**ROTHER LOCAL PLAN
2025-2042 –
DEVELOPMENT
STRATEGY AND SITE
ALLOCATIONS
CONSULTATION
RESPONSE
GROVE FARM, PHASE 2**

ACCESS REVIEW TECHNICAL NOTE

APPENDIX 4
HIGHWAYS PRE-APP RESPONSE

Location: Land at Grove Farm (Phase 2)
George Hill
Robertsbridge
TN32 5BY

Figure 3.2 – Option 2 access – north of Heathfield Gardens

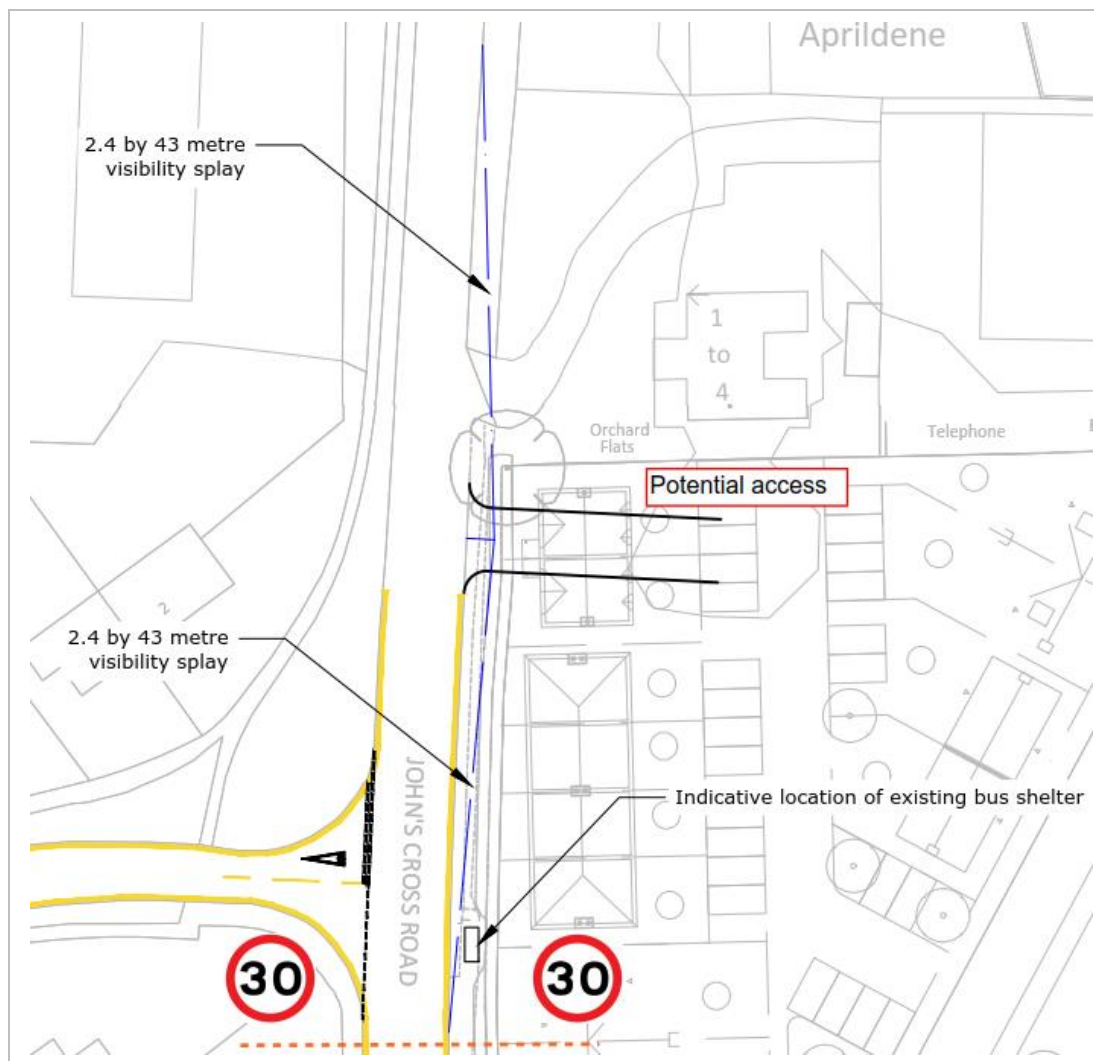
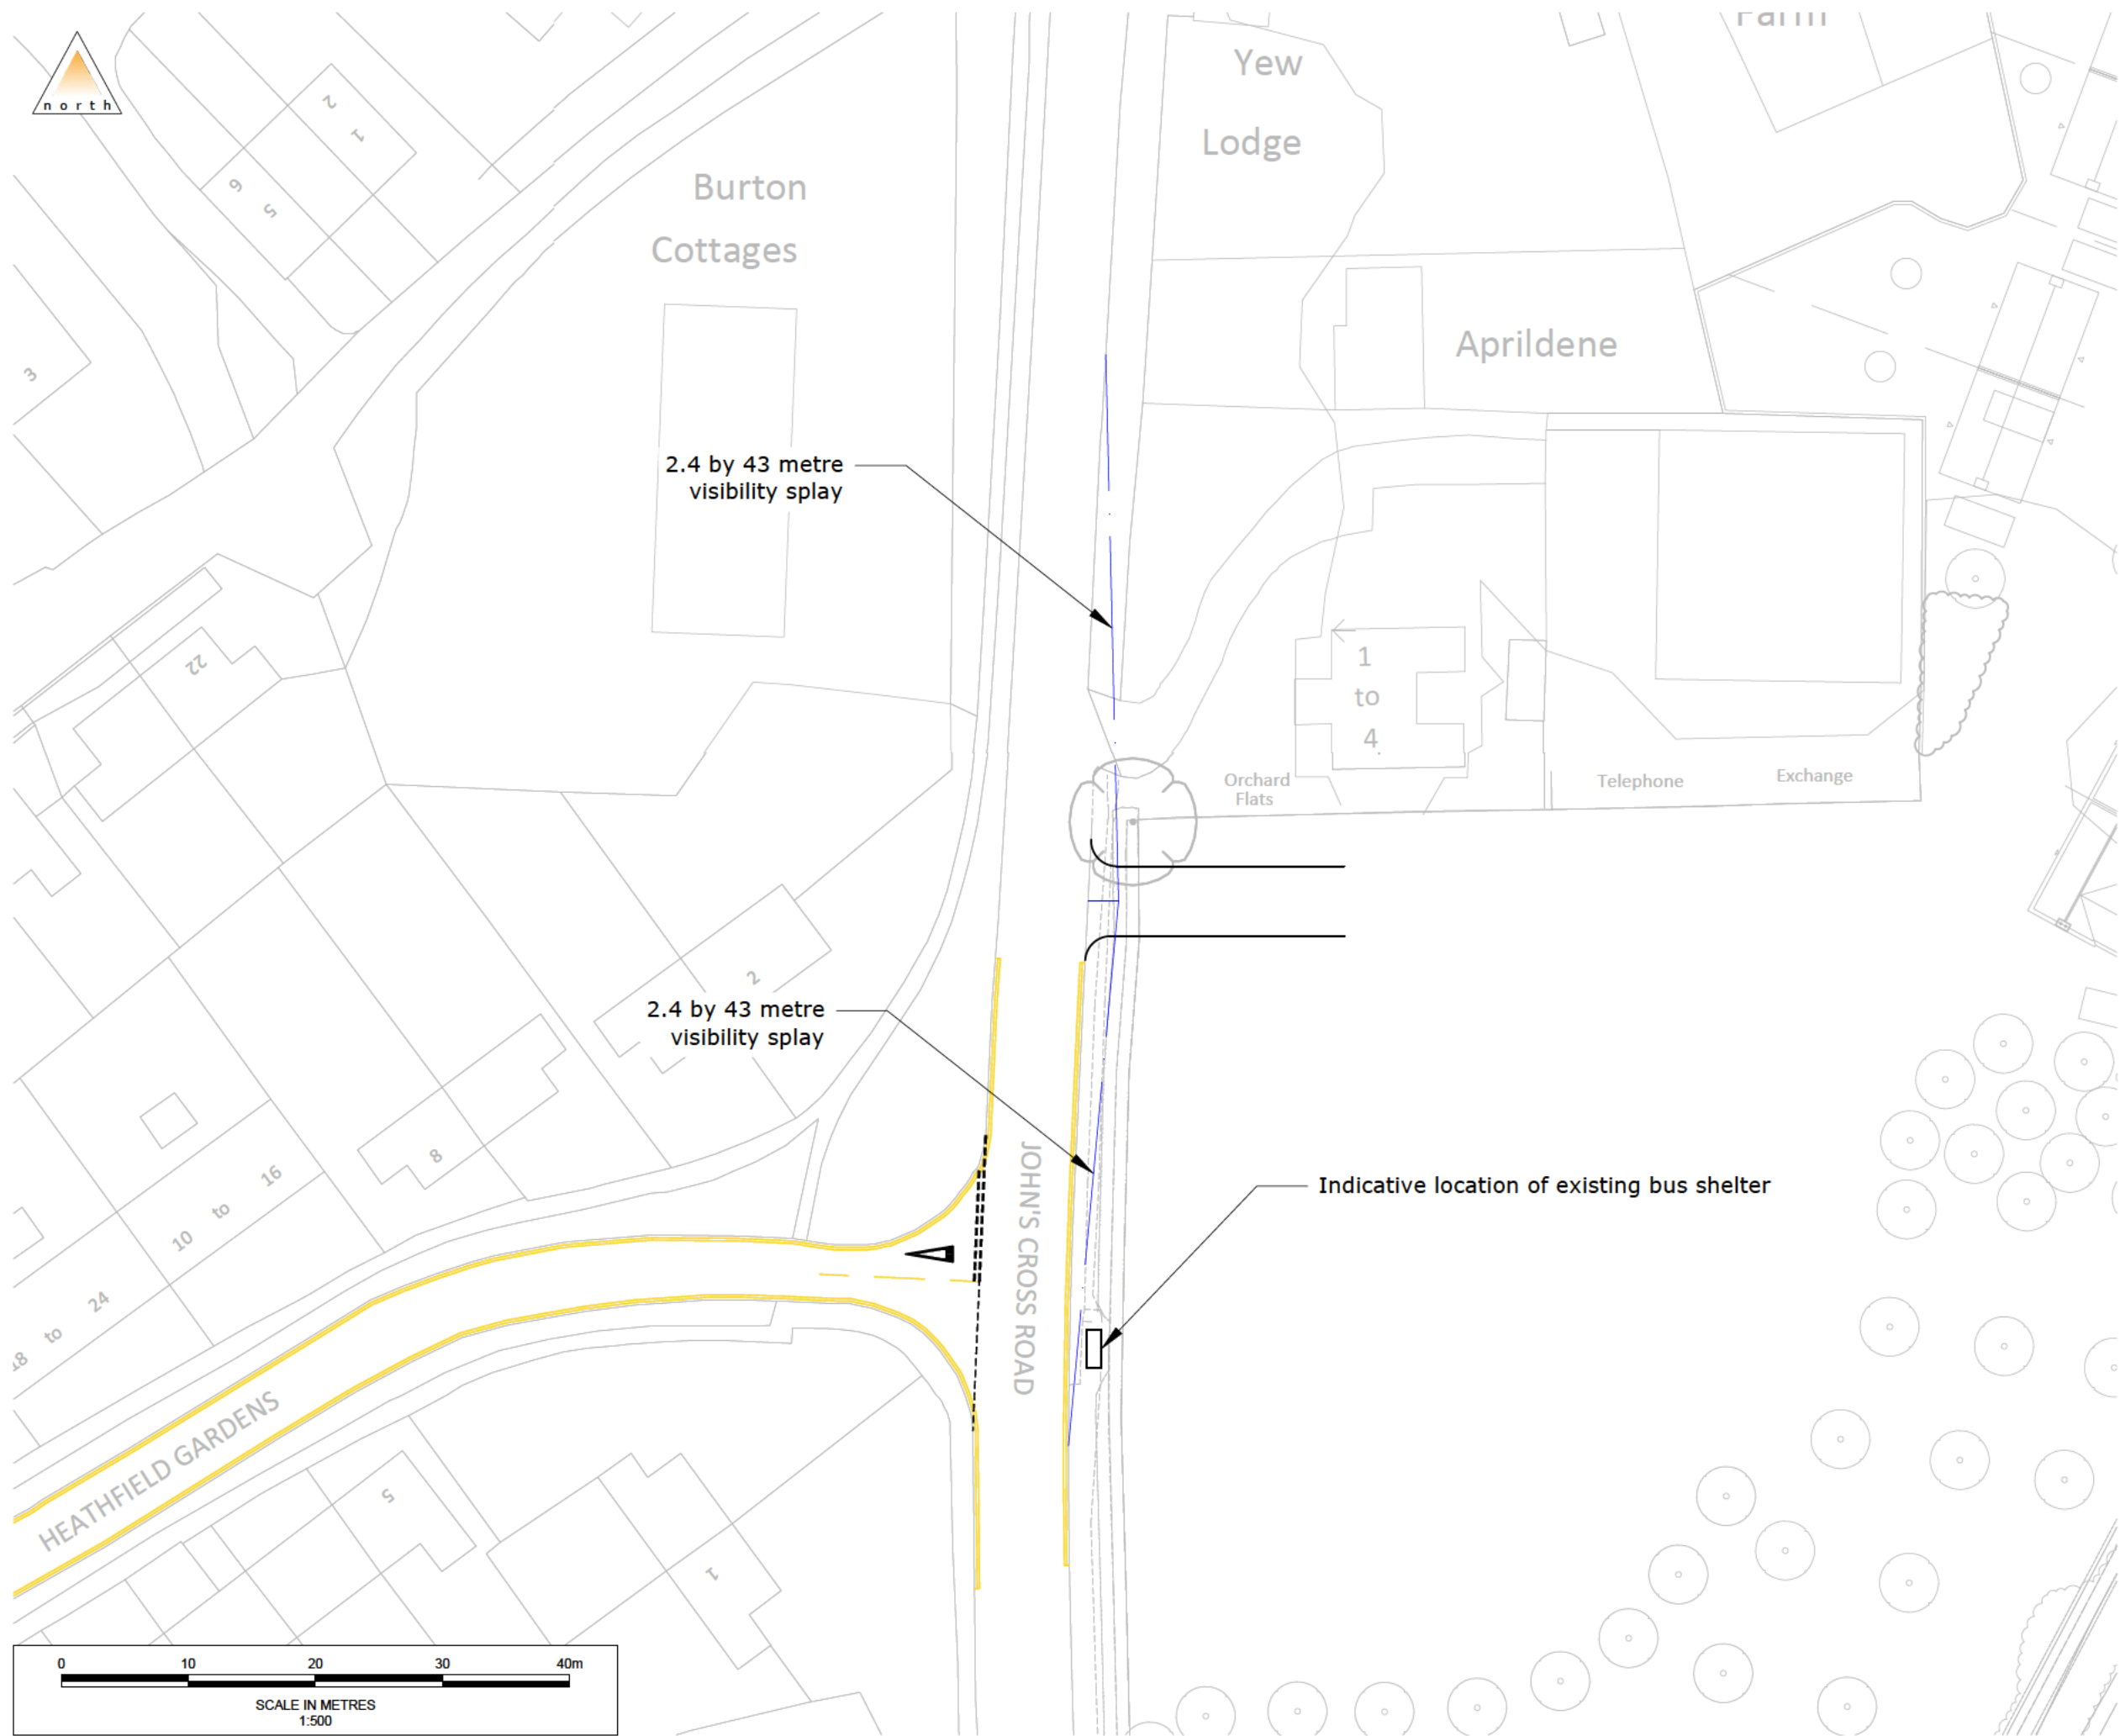
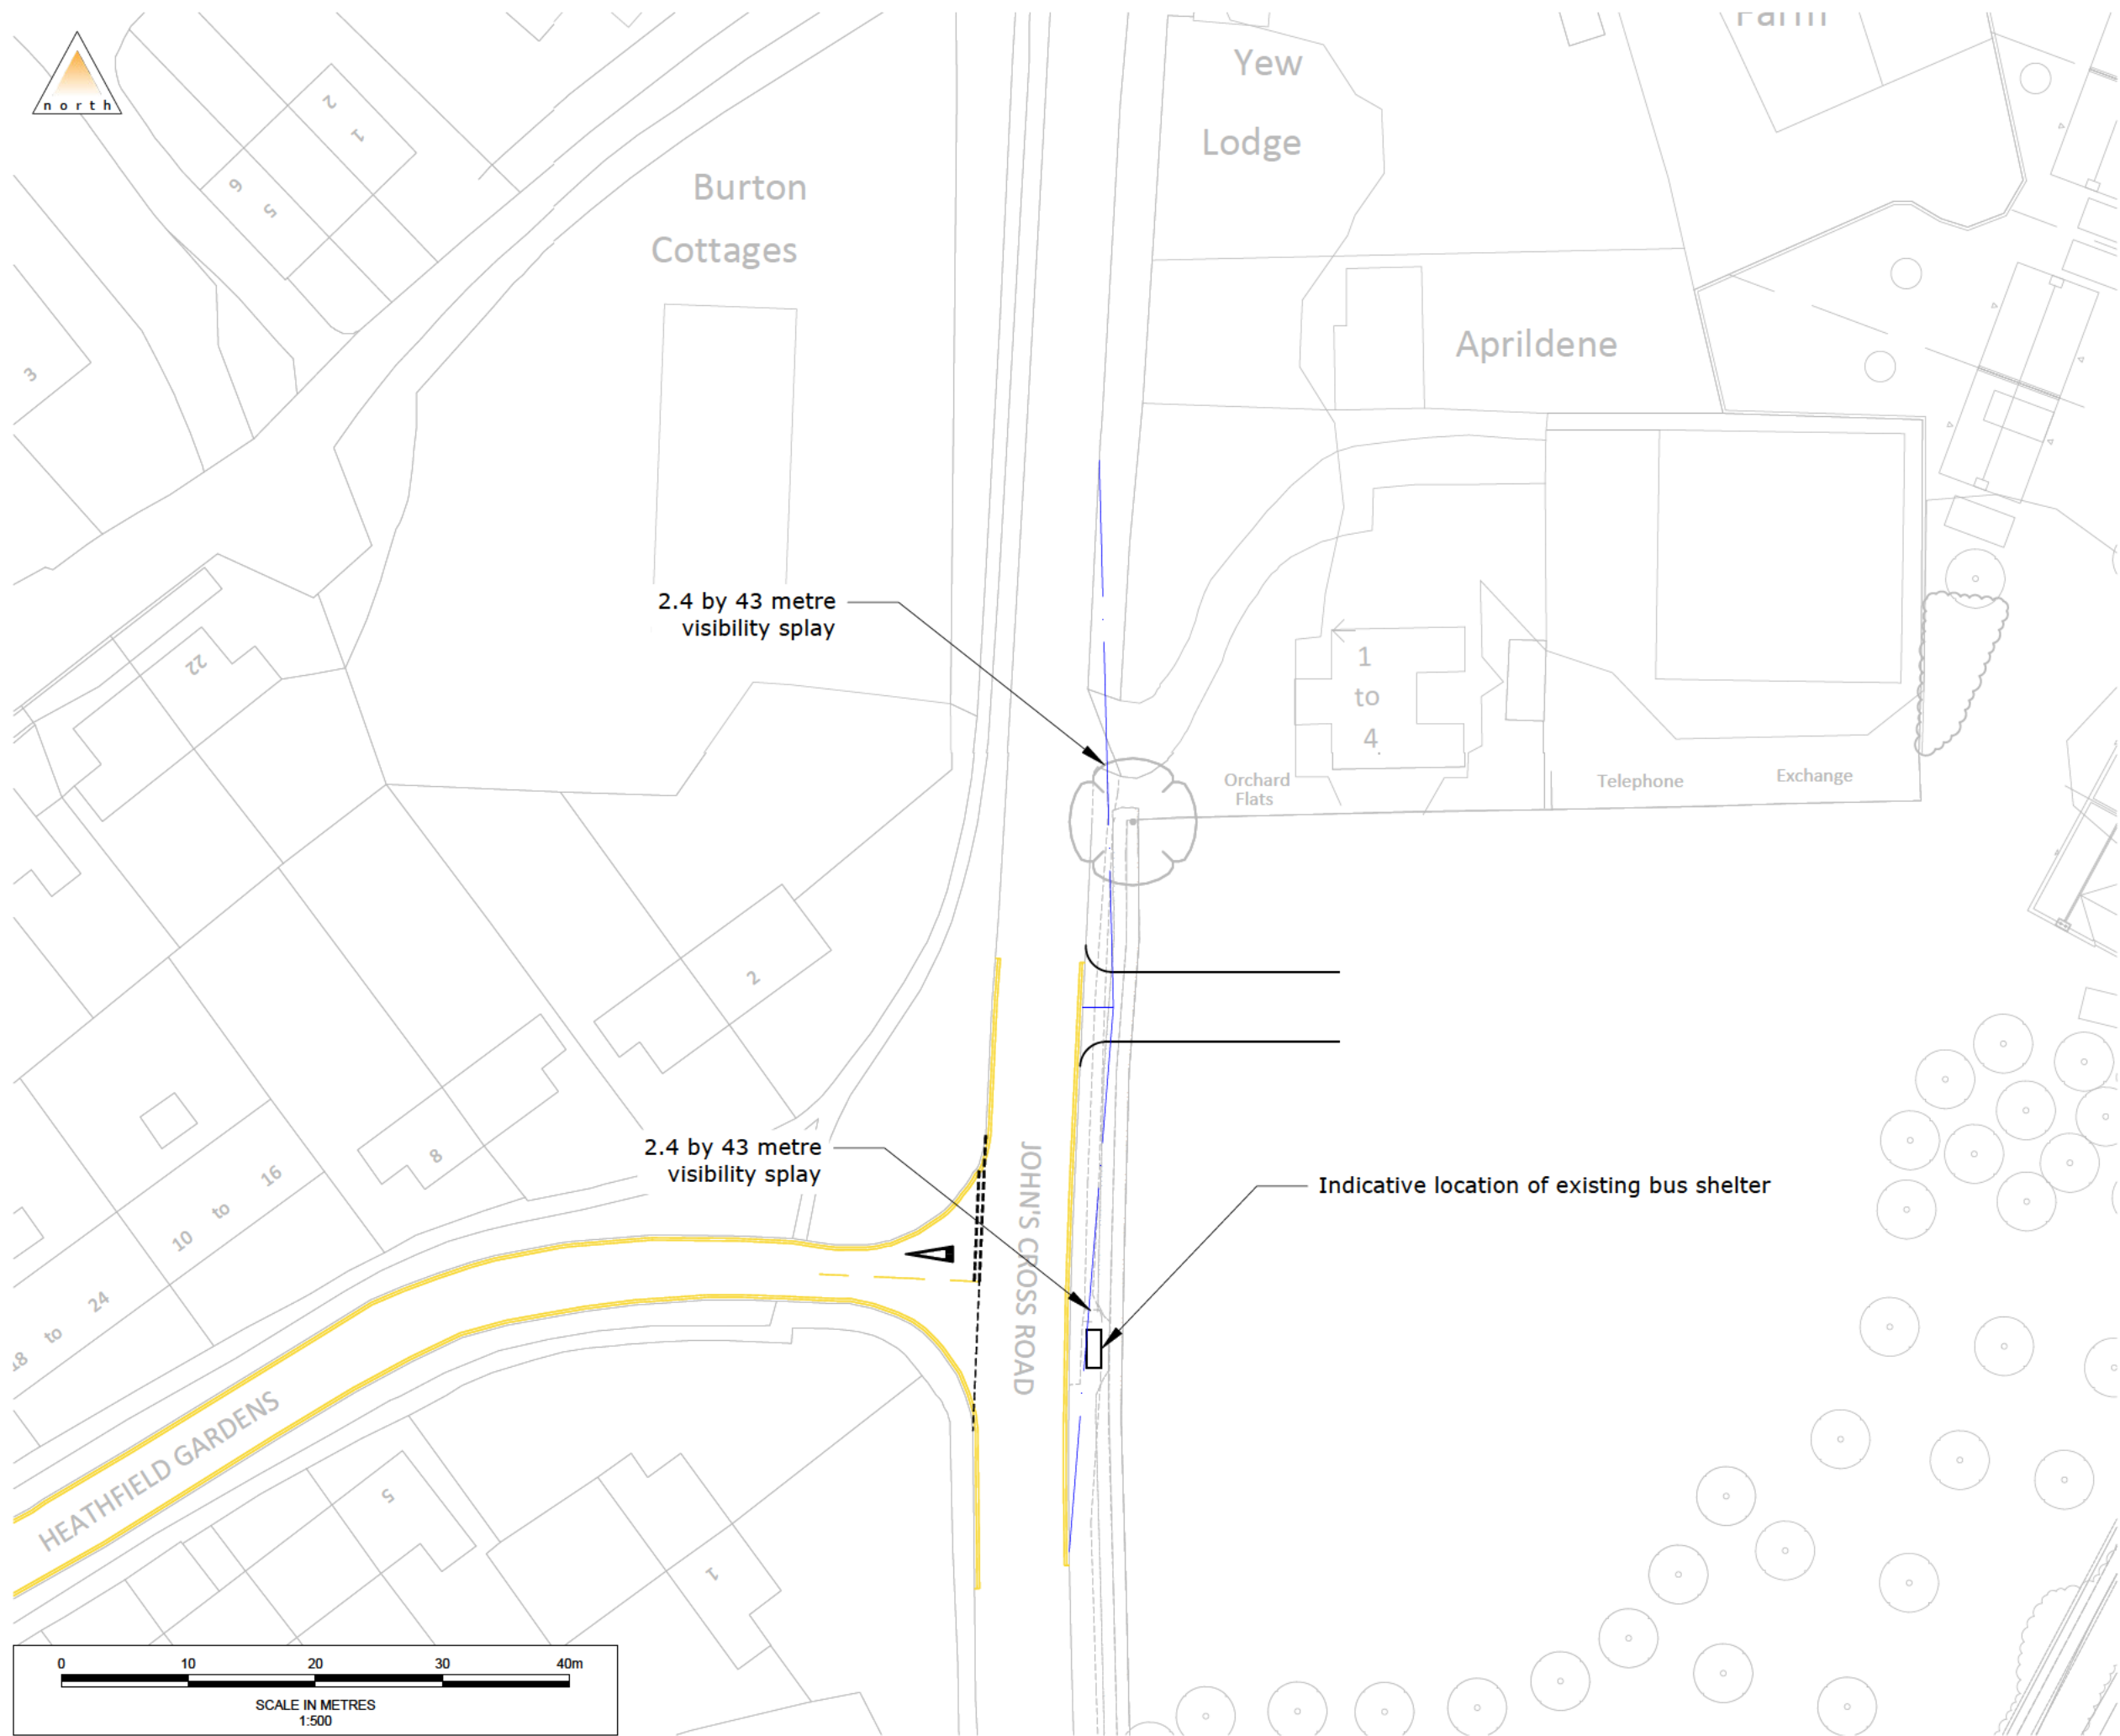
- ▶ The driver visibility splays to the north and south (2.4m x 43m) can be achieved on the basis that the vehicles are approaching at speeds in the order of 30mph. As with the comments provided for Option 1, the recorded traffic speeds along George Hill may be different from the assume speed limit and this will be known once the results from the ATC are obtained;
- ▶ The existing hedgerows will need to be trimmed back and maintained on a regular basis;
- ▶ The existing bus shelter to the south of the proposed junction will be clear of the required driver visibility;
- ▶ There is some flexibility in the extent of the splays should recorded speeds be higher, but there is a limit for the splay to the north due to third party land. If traffic speeds southbound along George Hill are higher

than 30mph, the Option 2 access may need to shift south to accommodate a longer splay. This will not be known until the ATC survey results are available; and

- ▶ The proximity of the access to Orchard Flats to the north will need to be considered as part of emerging design. It is recommended that the new Option 2 access be moved 15-20m south of the Orchard Flats access so that it is mid-way between Orchard Flats and the George Hill/Heathfield Gardens junction. This may impact the developable space within the site.

Of the three access options presented, option 2 is considered the most favourable in principle. This is because the access would be located within the 30mph speed limit, compared with the 50mph limit applicable to option 1, and therefore vehicle speeds are likely to be lower and the characteristics of this stretch of road are more aligned with MfS requirements rather than Design Manual for Roads and Bridges. Furthermore, for Option 1, the proximity of

- 3.17 The delivery of the Option 2 access from George Hill to serve the Phase 2 site will require existing hedgerows to be trimmed and maintained on a regular basis to ensure the driver visibility splays can be achieved. The Option 2 arrangement will need to be reviewed once the ATC survey is available.

Figure 3.3 – Option 3 access

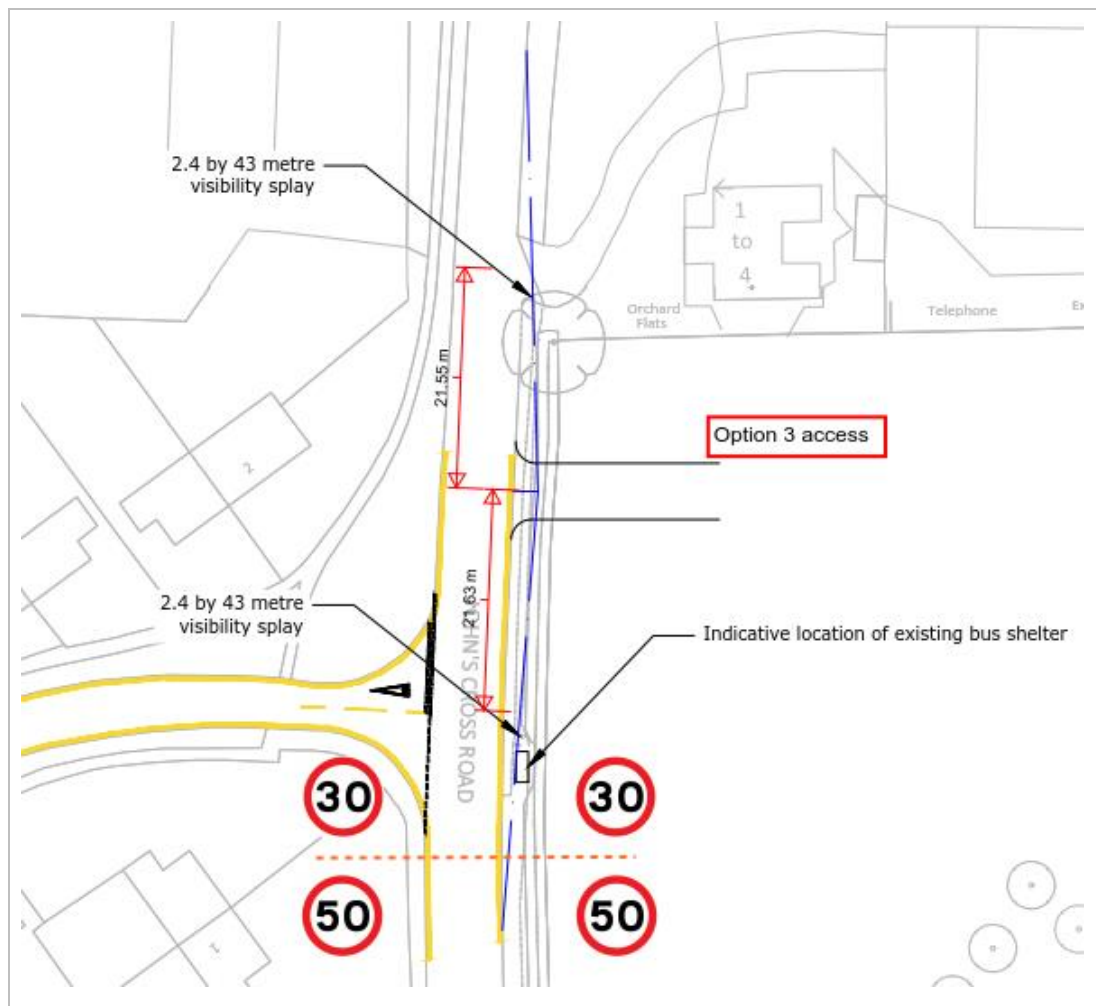
3.19 The centralisation of the proposed access between Orchard Flats and Heathfield Gardens provides a balance between the connections onto George Hill. The required driver visibility splays can be provided.

- ▶ The driver visibility splays to the north and south (2.4m x 4.3m) can be achieved on the basis that the vehicles are approaching at speeds in the order of 30mph. The splays will need to be confirmed further to the traffic speed surveys;
- ▶ The existing hedgerows will need to be trimmed back and maintained on a regular basis; and
- ▶ The existing bus shelter to the south of the proposed junction will be clear of the required driver visibility.

Option 3, whilst also within the 30mph speed limit, is located closer to the Heathfield Gardens junction than Option 2, and this would also be a concern.

3.21 The delivery of the Option 3 access from George Hill will provide a better solution in traffic terms but will need to be balanced out with the masterplan layout. The provision of the driver visibility splays in theory be provided within the road space but the existing hedges will need to be trimmed, in accordance with typical maintenance, to ensure the required splays can be delivered.
